Bill Johnson
NOBLE HOUSE

CHELMSFORD ROOD CONDITION AND LEAK SURVEY 05/05/2022, 9:05 AM

Thursday, 5 May 2022

ITEM 4

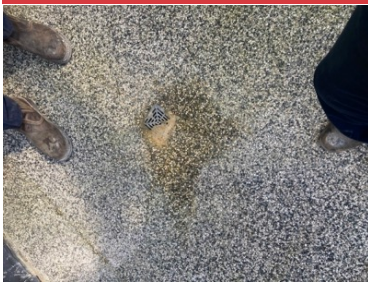
Door plate needs removing to investigate in and around threshold. If resin finishes at door line, it will need removing in order to investigate the build up. Please refer to items 11 & 12 as the Up-stands don't seem to be sufficient and high enough to keep water out the building?

ITEM 13

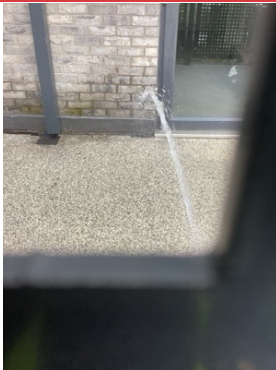
Expansion joint in car park growing fungi suggesting water/damp issues.
